**UNITED NUCLEAR**  
CORPORATION

Subject: Amendment to SNM 777

Please amend License SNM 777 to incorporate changes as indicated on the attached revised pages and drawings.

**302.8.1 General Description Oxygen Burning Facility**

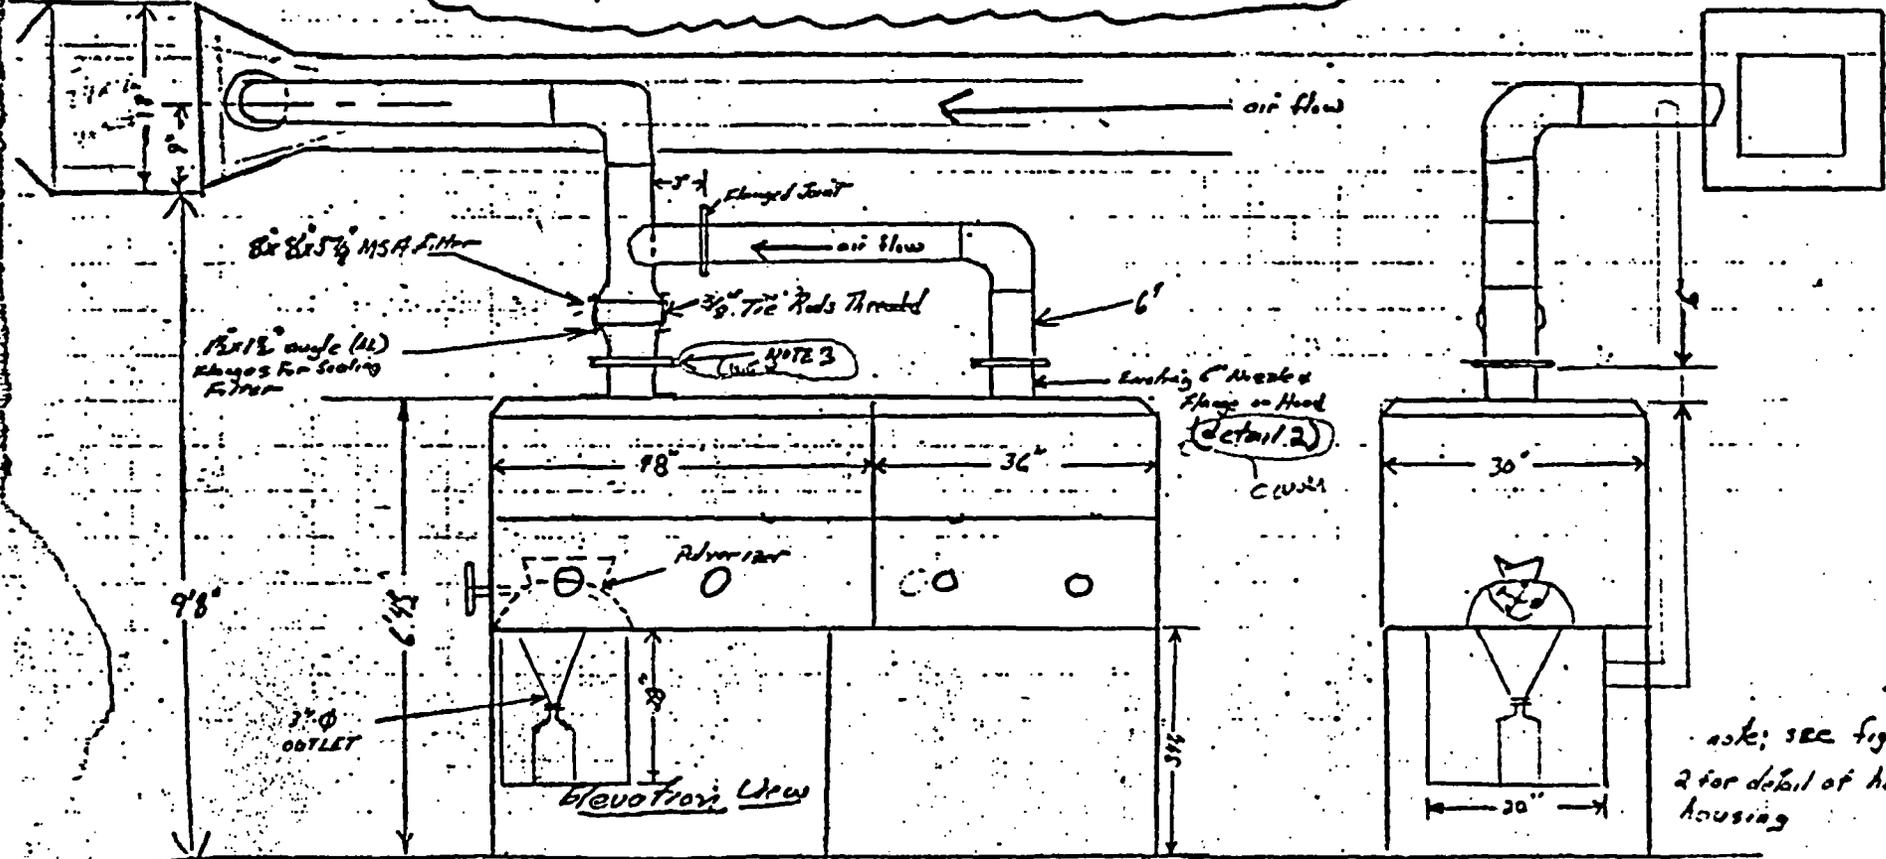
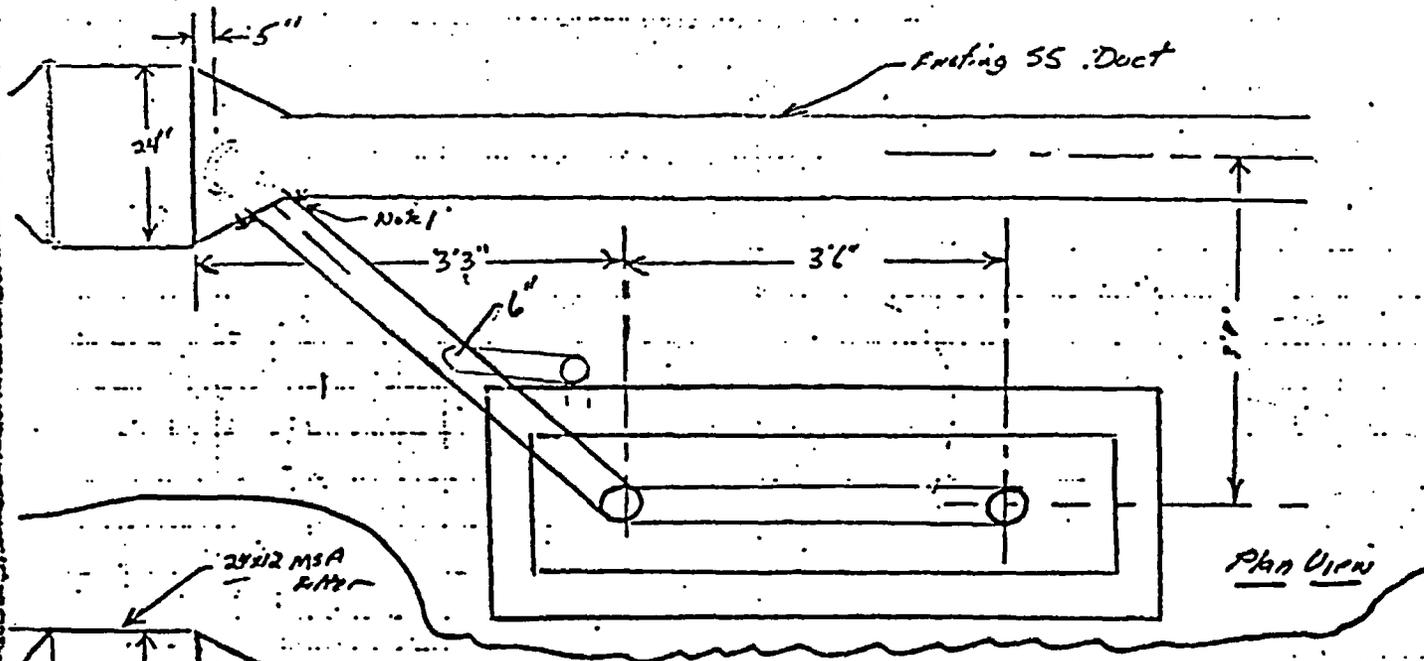
This Hood is 30" deep x 84" long x 42" high. The section housing the Pulverizer is 48" long and is connected to the adjacent chamber by a sliding vertical door. The drive motor for the Pulverizer is externally mounted. Ventilation to the Hood is provided by three ducts leading from each end of the Hood and the withdrawal chamber to an existing exhaust system. The air from the Pulverizer chamber is filtered through an 8 x 8 x 5-7/8 absolute filter before entering the present exhaust system which has additional filtering. The air from the entrance and withdrawal chamber passes into the present exhaust system before additional filtering. See Figure 1 and 2.

# DIAGRAM 2

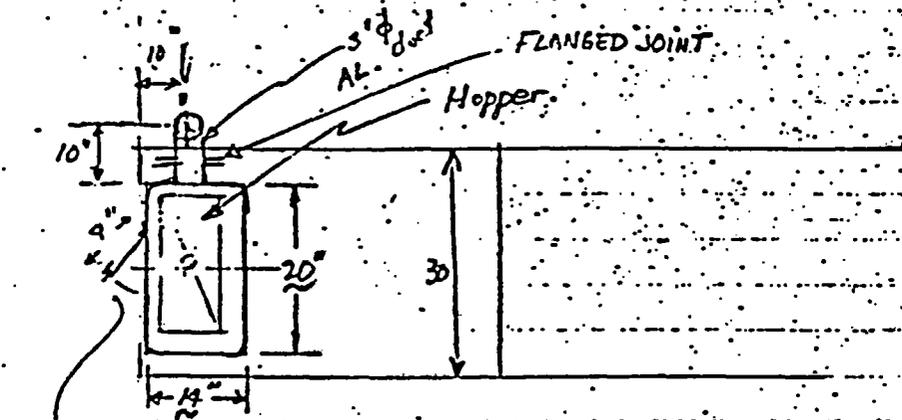
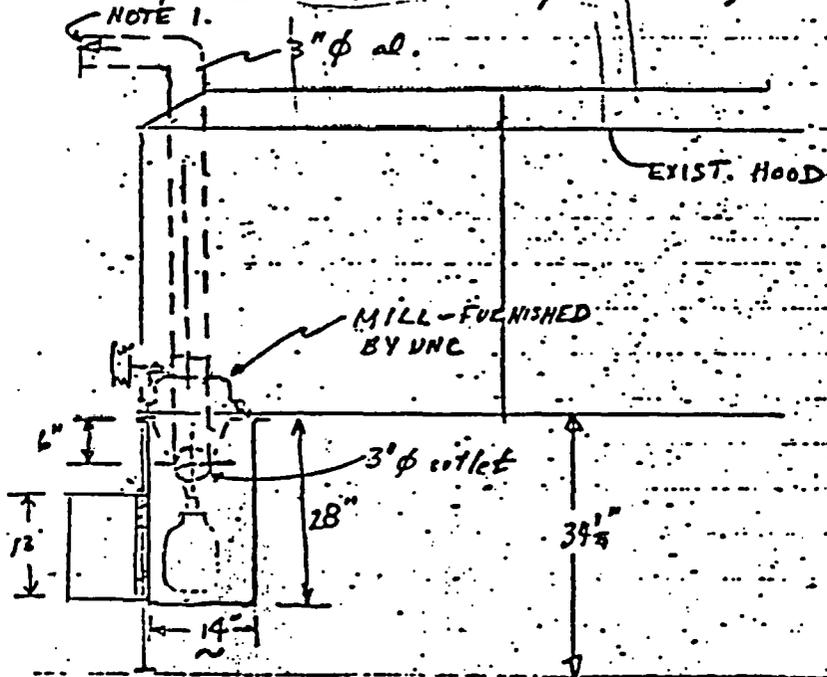
1. Connect, 3"  $\phi$  Al. duct to 6" duct as shown on RI 386 INQUIRY.

2. Material of const. 18-8 type S.S.

door opening 8" wide x 12" high hinged with continuous piano hinge S.S. and latched at top & bottom.
